AL67-3D

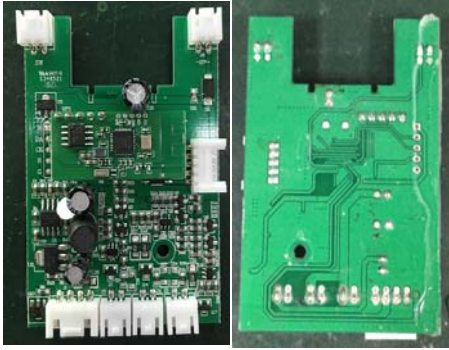
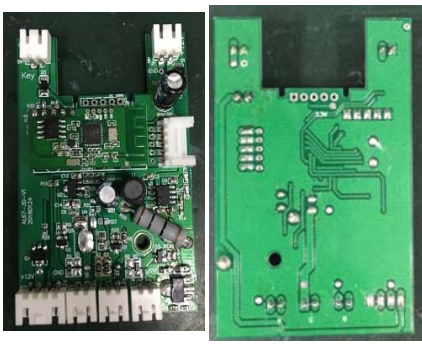
After	before
<p>PCBA:Modify the driving mode of laser diode,constant voltage changed to constant voltage +constant current , pcbayout changed</p>

<p>Add a heat sink to reduce the internal temperature</p>
